Minutes of the North Carolina Building Code Council
March 10, 2020
Washington, NC

Part A Administrative Items

Part B – New Petition for Rulemaking

**FIGURE AM105.2
TYPICAL DECK GIRDER SPANS**

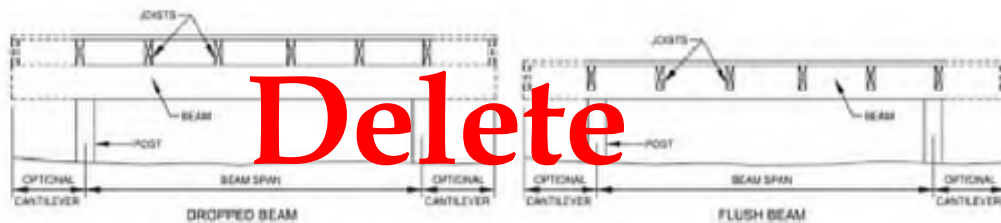
~~**AM105.2 Girder span for uncovered porches and decks.** Maximum allowable spans for wood deck girders, as shown in Figure AM105.2, shall be in accordance with Table AM105.2. Girder plies shall be fastened with two rows of 10d (3-inch x 0.128-inch) nails minimum at 16 inches (406 mm) on center along each edge. Girders shall be permitted to cantilever at each end up to one fourth of the actual beam span. Splices of multispan beams shall be located at interior post locations.~~

FIGURE AM106.1
TYPICAL DECK JOIST SPANS

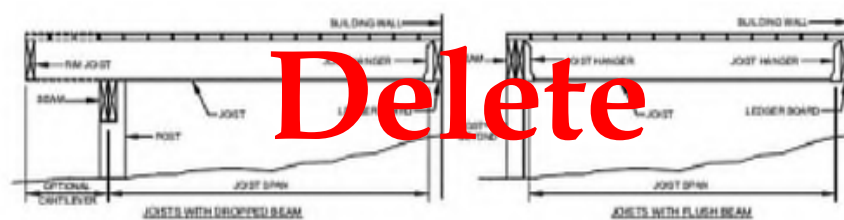
~~**AM106.1 Joist spans for uncovered porches and decks** and cantilevers. Joists spans shall be based upon Table R502.3.1(2) with 40lbs per sq ft of live load and 10 lbs per sq ft of dead load. Floor joists for exterior decks may be cantilevered per Table R502.3.3(1). Maximum allowable spans for wood deck joists, as shown in Figure AM106.1, shall be in accordance with Table AM106.1. Deck joists shall be permitted to cantilever not greater than one-fourth of the actual, adjacent joist span.~~

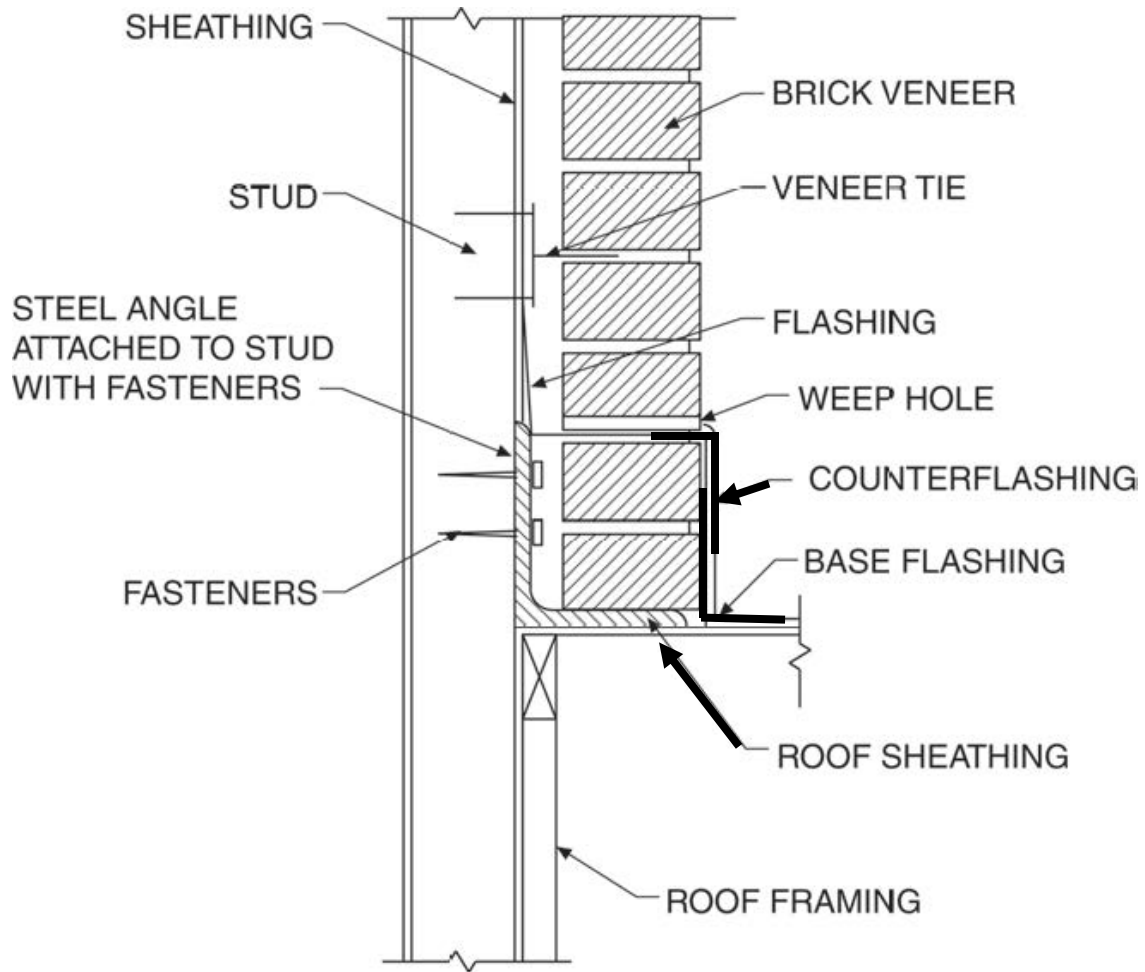
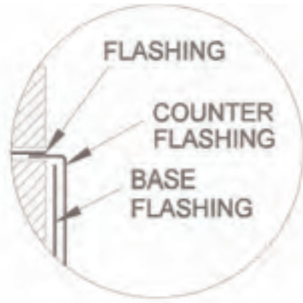
R312.1.3 Opening limitations. Required *guards* shall not have openings from the walking surface to the required *guard* height that allow passage of a sphere 4 inches (102 mm) in diameter.

1. The triangular openings at the open side of stair, formed by the riser, tread and bottom rail of a *guard*, shall not allow passage of a sphere 6 inches (153 mm) in diameter.
2. *Guards* on the open side of stairs shall not have openings that allow passage of a sphere 4 3/8 inches (111 mm) in diameter.
3. The opening between adjacent treads is not limited on stairs with a total rise of 30 inches (762 mm) or less.

**FIGURE R703.8.2.1
EXTERIOR MASONRY VENEER SUPPORT BY STEEL ANGLES**

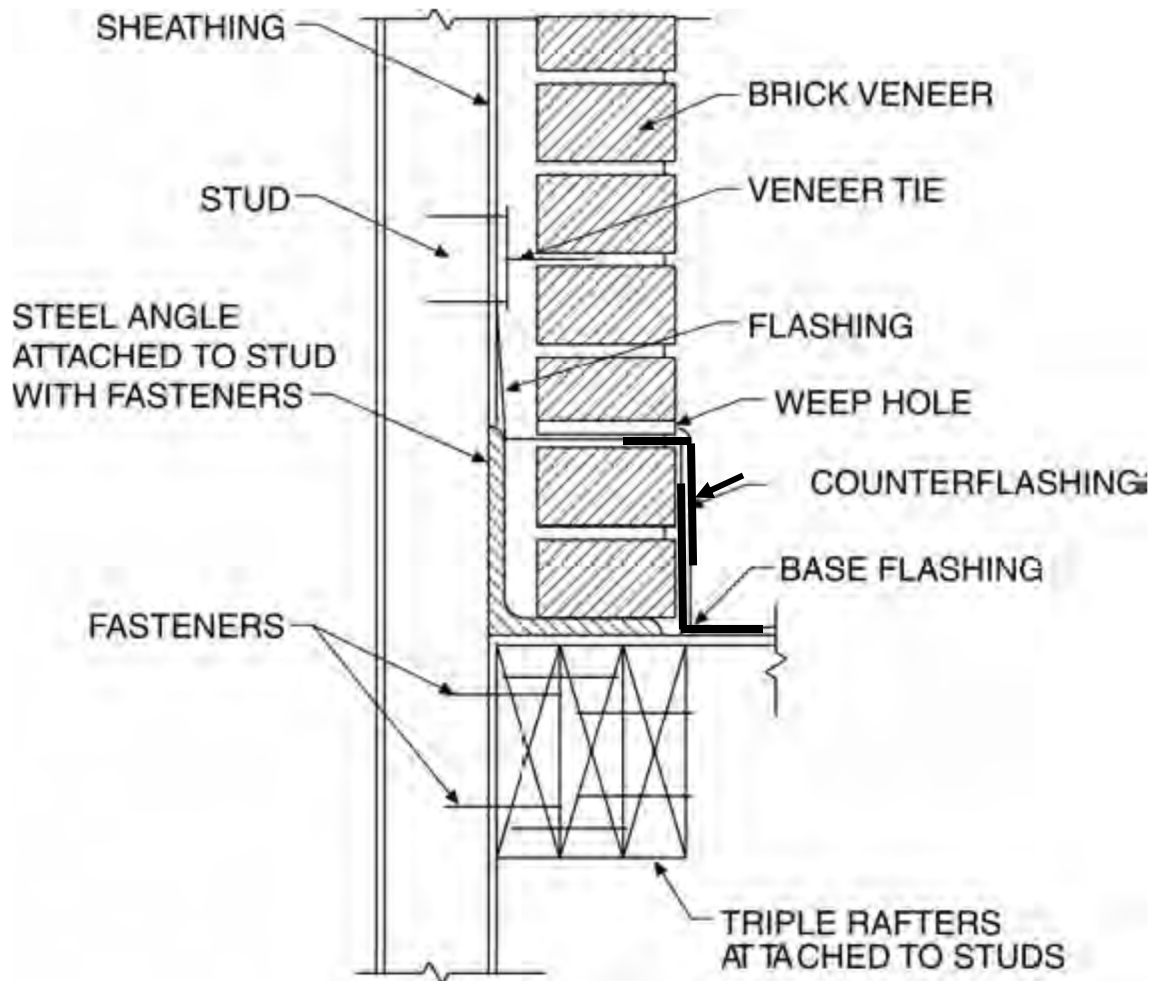
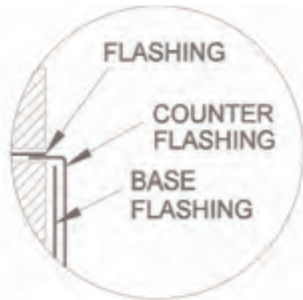
R703.8.2.1 Support by steel angle. A minimum 6-inch by 4-inch by 5/16-inch (152 mm by 102 mm by 8 mm) steel angle, with the long leg placed vertically, shall be anchored to double 2-inch by 4-inch (51 mm by 102 mm) wood studs at a maximum on-center spacing of 16 inches (406 mm). Anchorage of the steel angle at every double stud spacing shall be a minimum of not less than two 7/16-inch diameter (11 mm) by 4-inch (102 mm) lag screws for wood construction at every double stud or shall be a minimum of two 7/16-inch diameter (11.1 mm) by 4 inches (102 mm) lag screws into solid double blocking with each pair of lag screws spaced at horizontal intervals not to exceed 16 inches (406 mm). The steel angle shall have a minimum clearance to underlying construction of 1/16 inch (1.6 mm). ~~Not less than~~ A minimum of two-thirds the width of the masonry veneer thickness shall bear on the steel angle. Flashing and weep holes shall be located in the masonry veneer in accordance with Figure R703.8.2.1. The maximum height of masonry veneer above the steel angle support shall be 12 feet 8 inches (3861 mm). The airspace separating the masonry veneer from the wood backing shall be in accordance with Sections R703.8.4 and R703.8.4.2. The method of support for the masonry veneer on ~~wood construction~~ steel angle shall be constructed in accordance with Figure R703.8.2.1.

The maximum slope of the roof construction without stops shall be 7:12. Roof construction with slopes greater than 7:12 but not more than 12:12 shall have stops of a minimum 3-inch by 3-inch by 1/4-inch (76 mm by 76 mm by 6.4 mm) steel plate welded to the angle at 24 inches (610 mm) on center along the angle or as approved by the building official.

Table AM109.1.4
FASTENING OF BRACE (CHOOSE ONE)

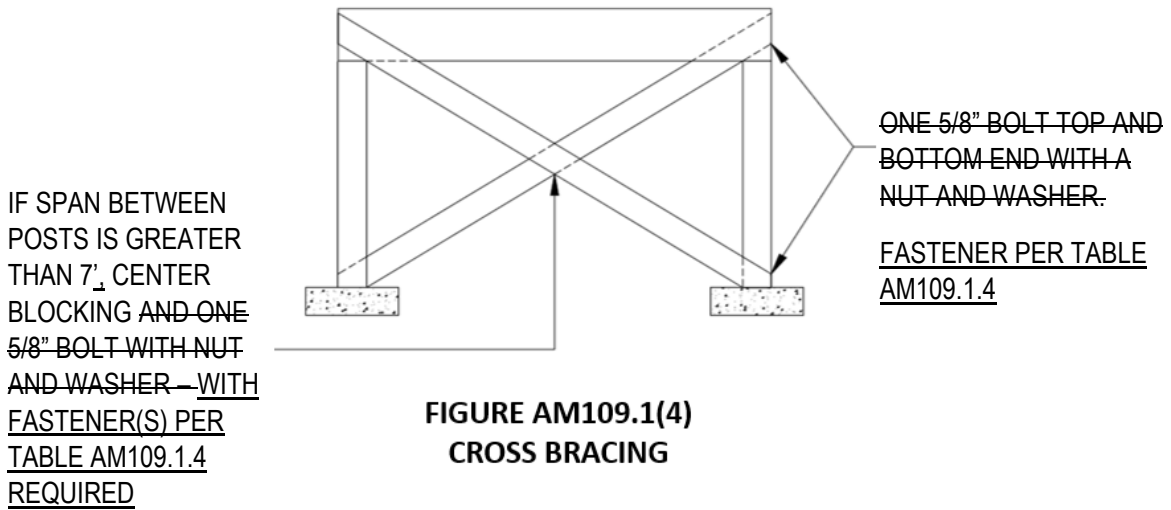
2x6 diagonal vertical cross bracing is permitted to be provided in two perpendicular directions for free standing decks or parallel to the structure at the exterior column line for attached decks. The 2x6 bracing shall be attached to the posts with one of the methods in Table AM109.1.4 ~~5/8-inch (16 mm) hot dip galvanized bolt with nut and washer~~ at each end of each bracing member in accordance with Figure AM109.1(4).
